**ADDENDUM No. 2**

Date: June 5, 2026

Project: Hector International Airport  
Terminal Apron Reconstruction – Phase 2

**C-453R**

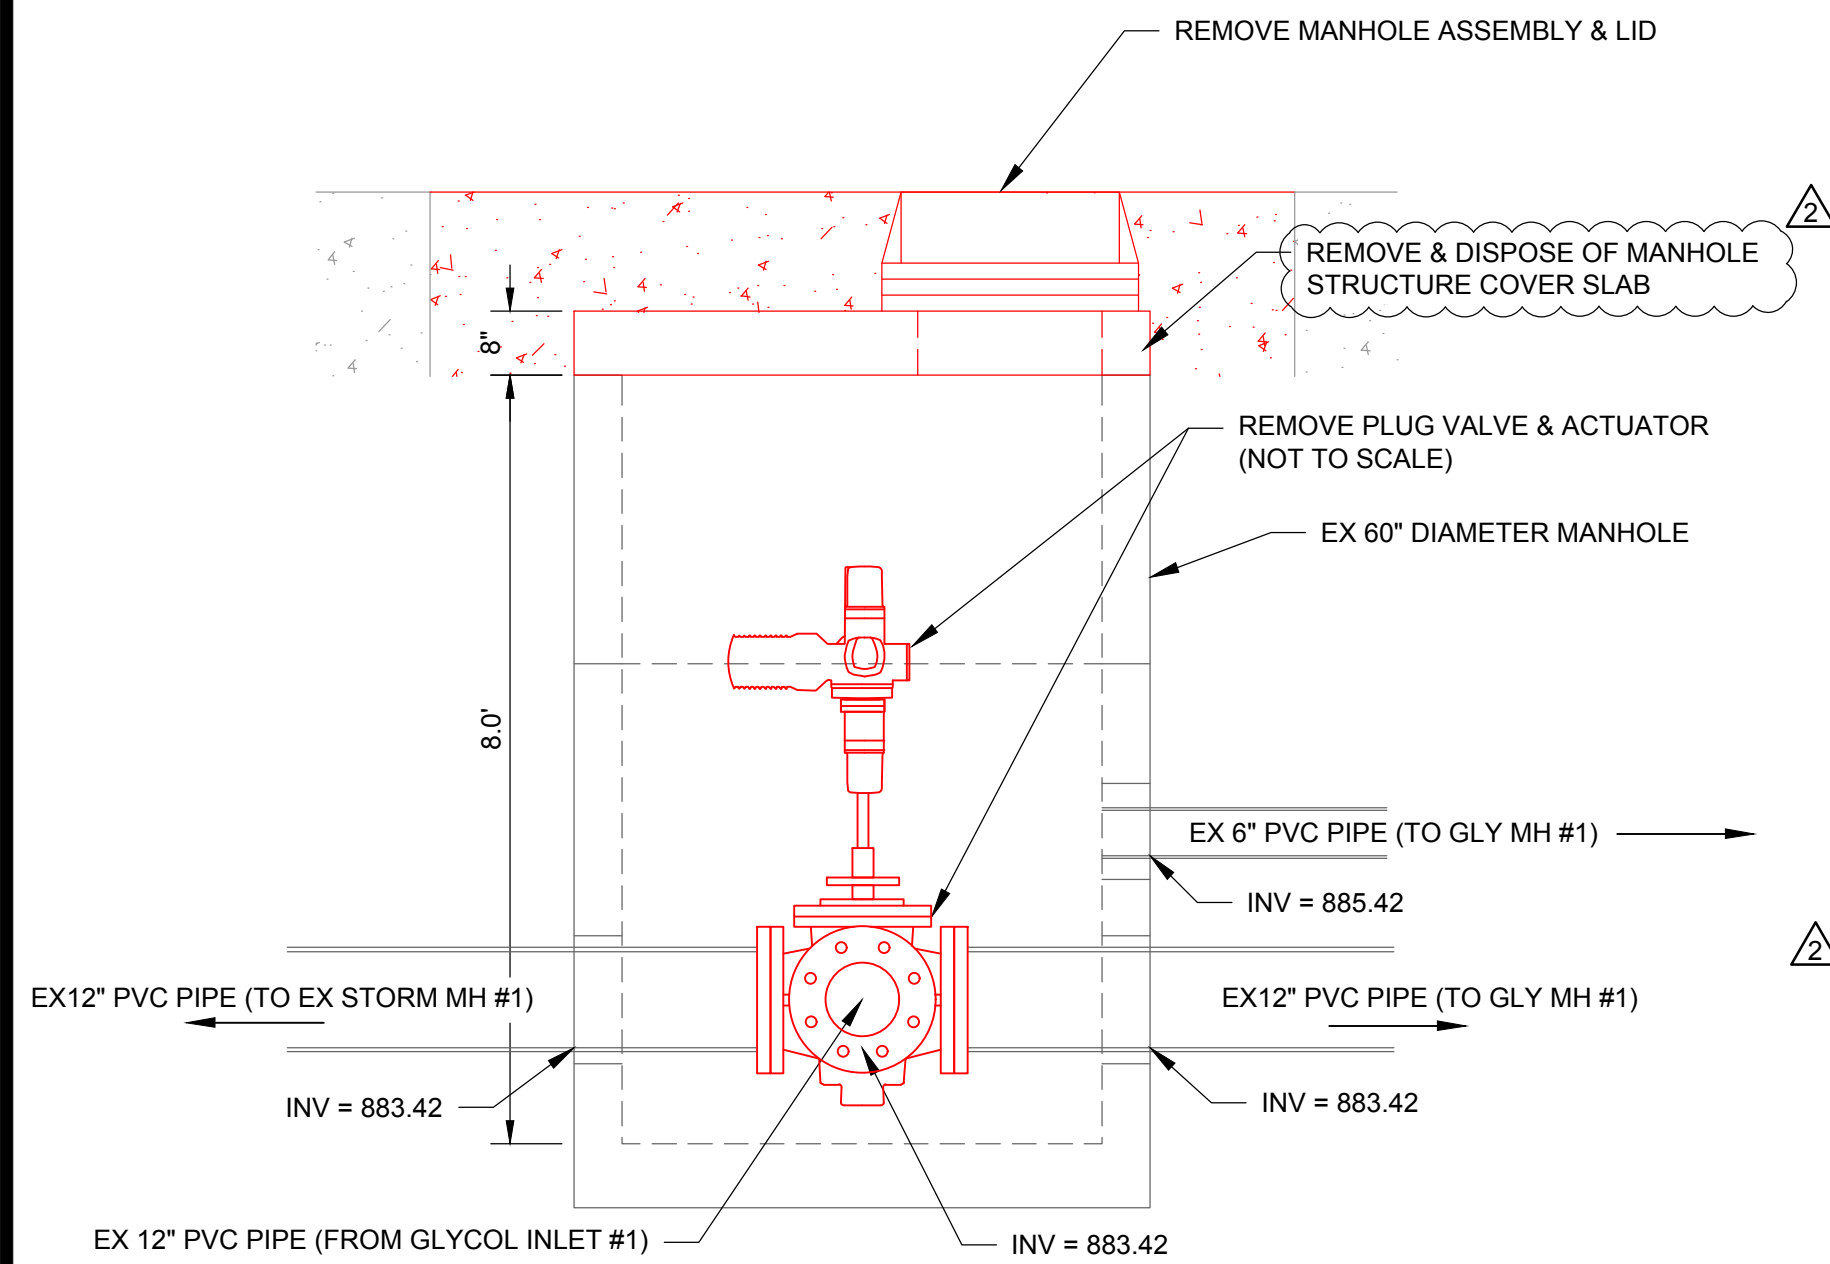
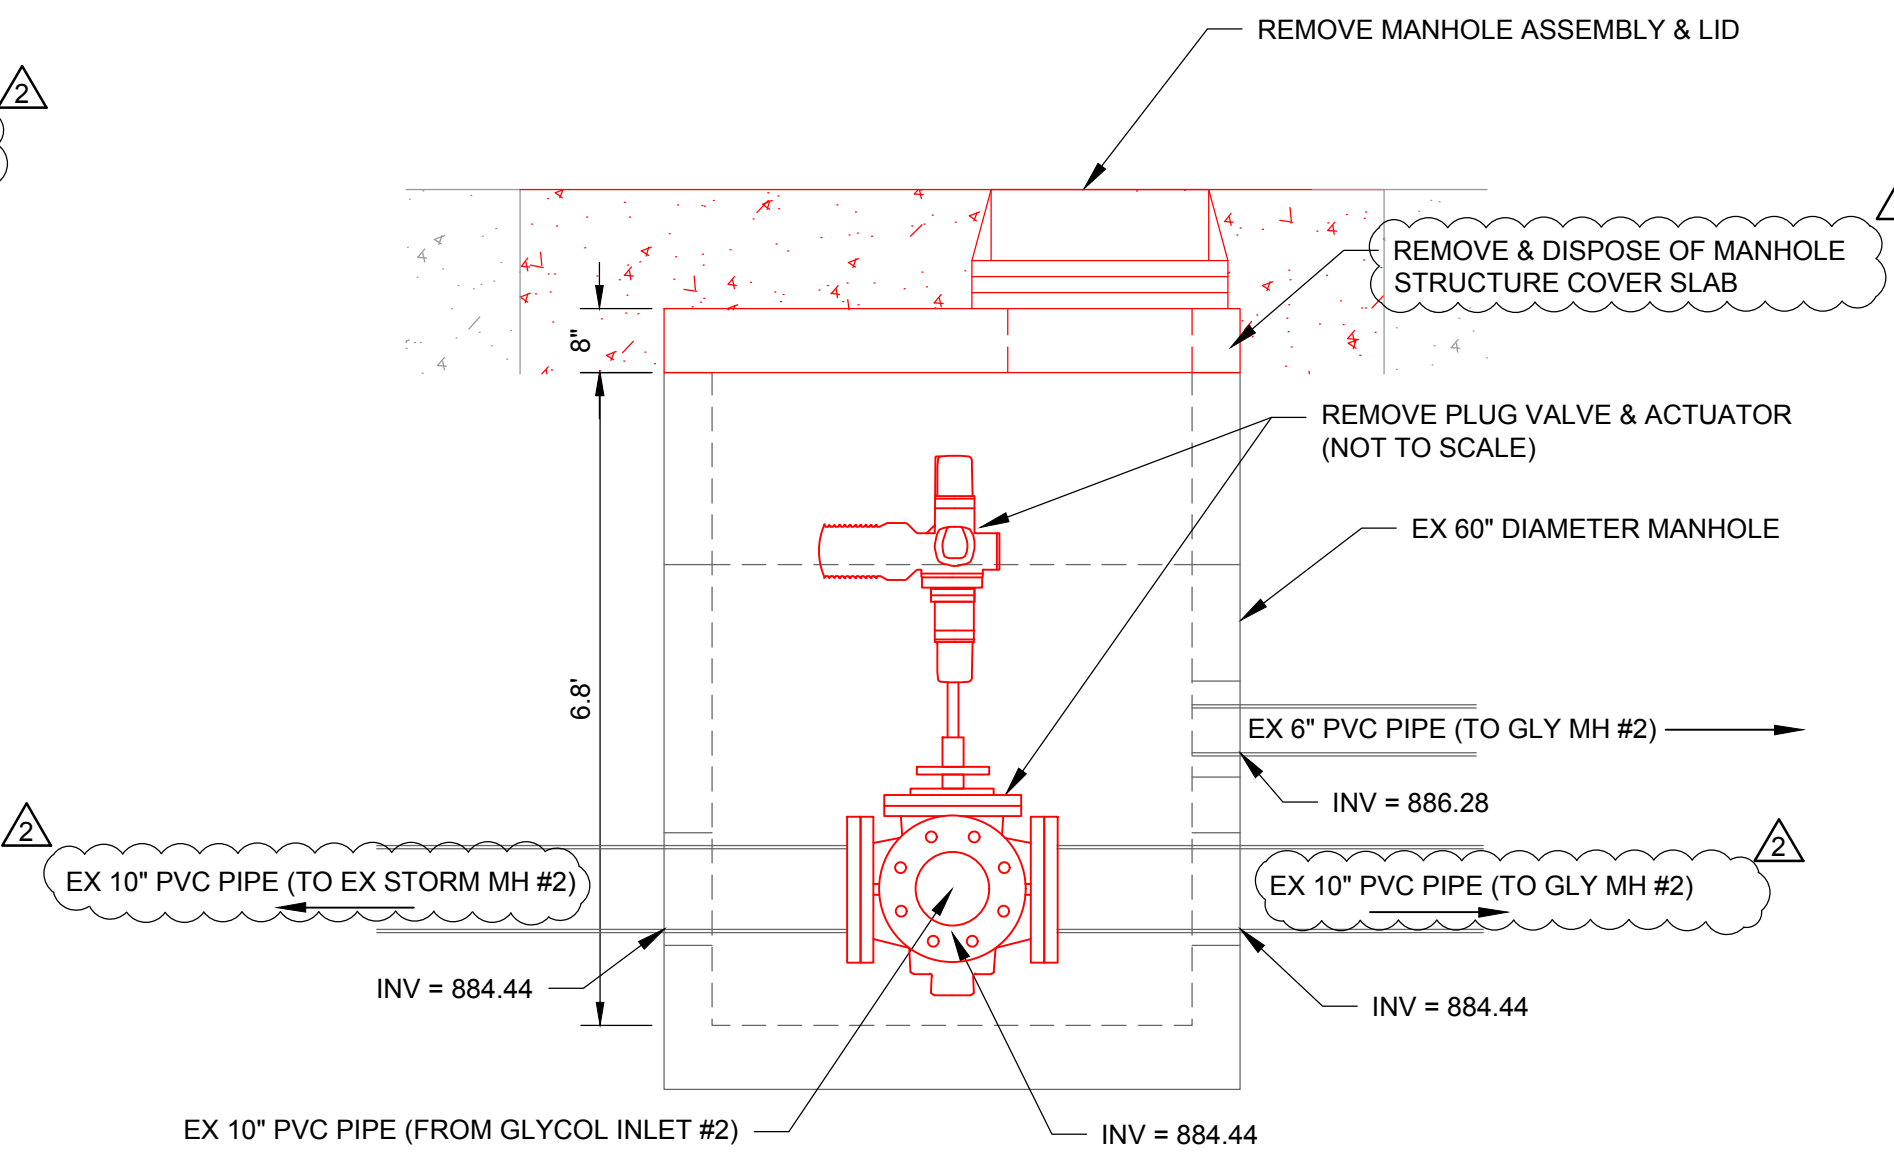
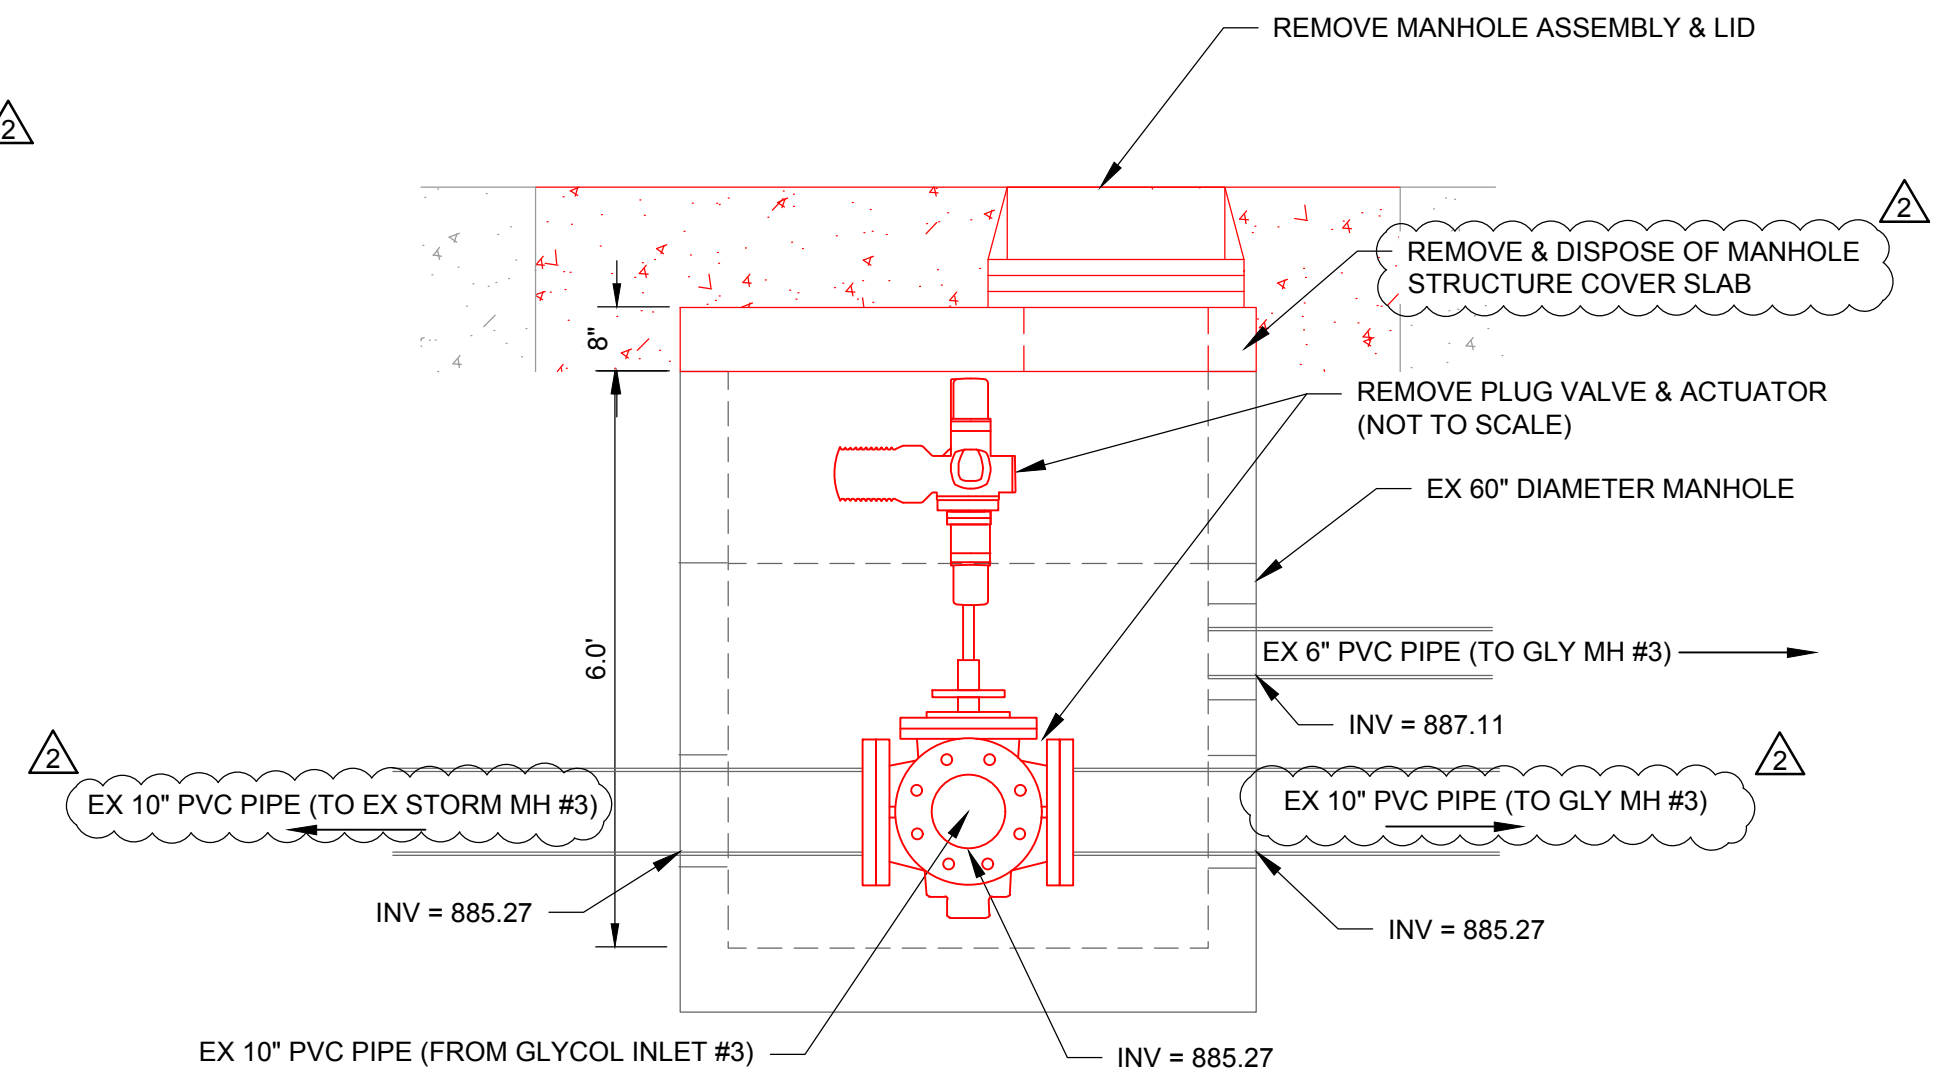
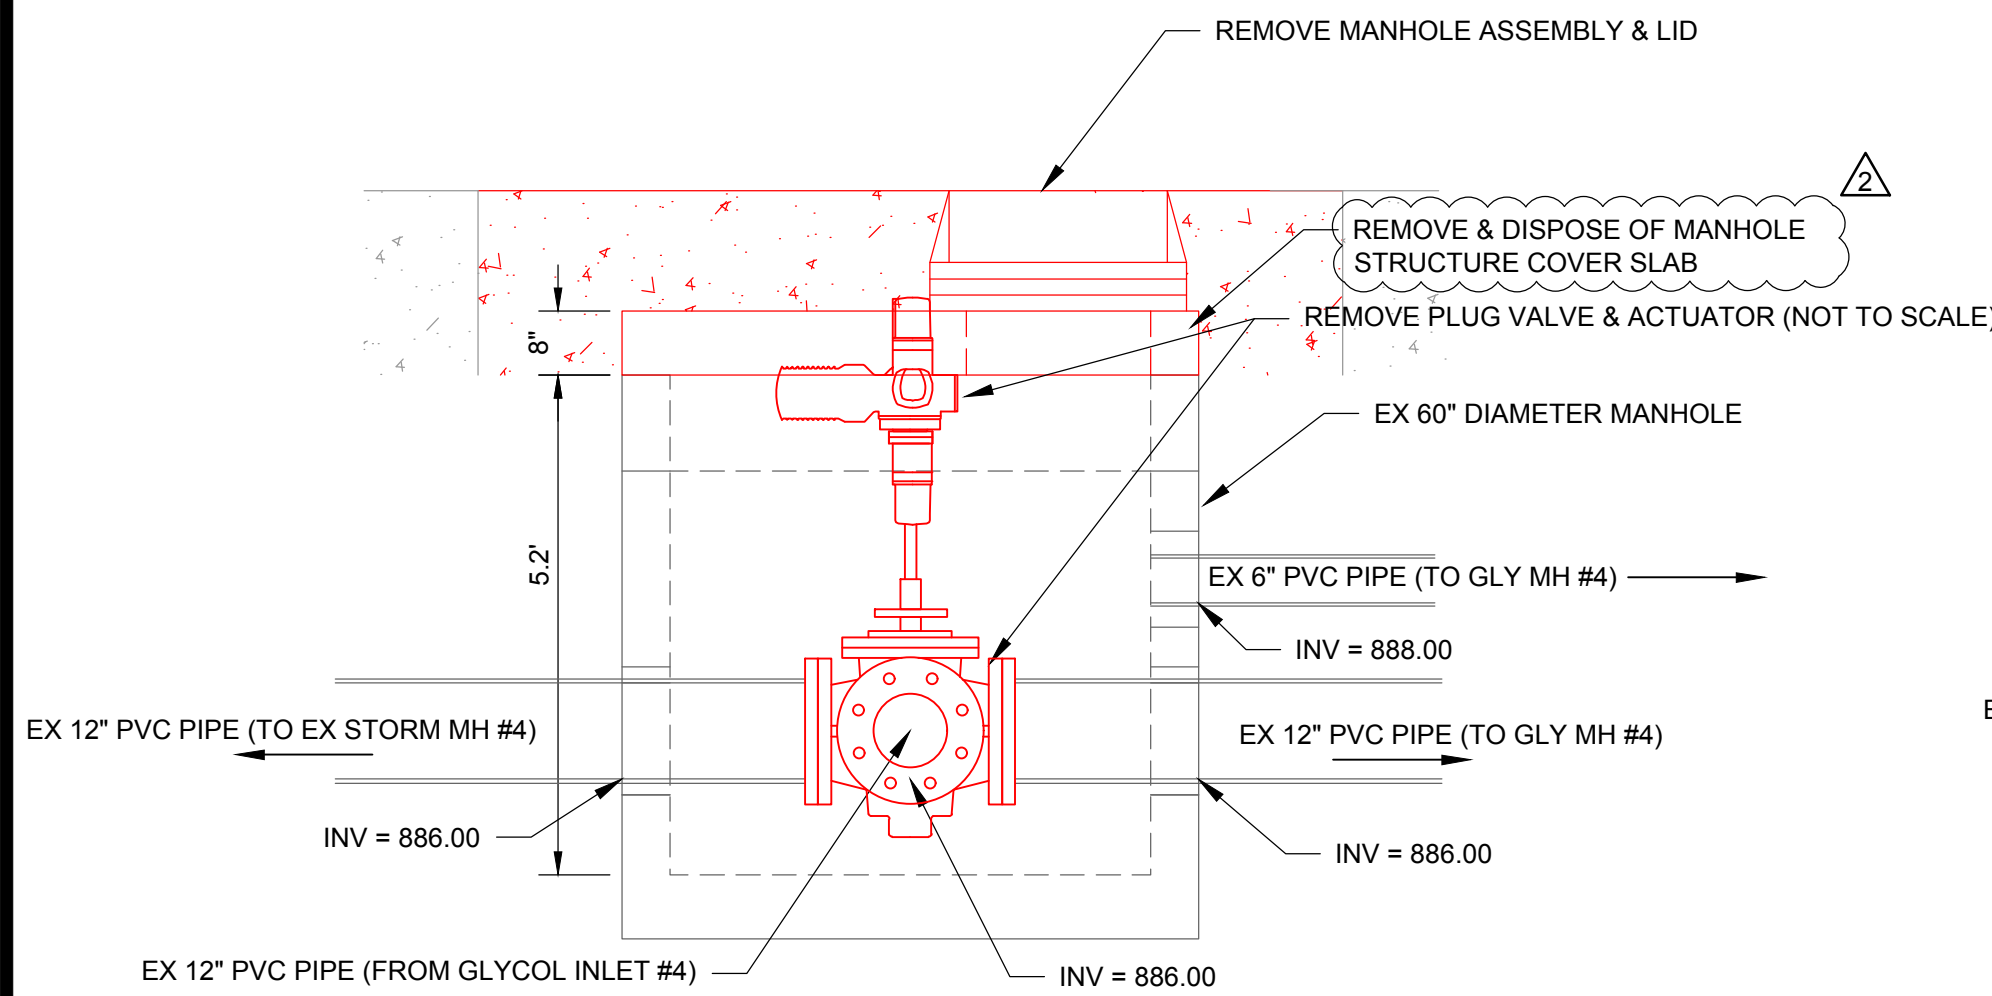
### **5. Sheet C-453 EXISTING VALVE MANHOLE REMOVALS**

- I. Add more leaders clarifying removals
- II. Correct existing pipe labels
- III. Add notes 5 and 6
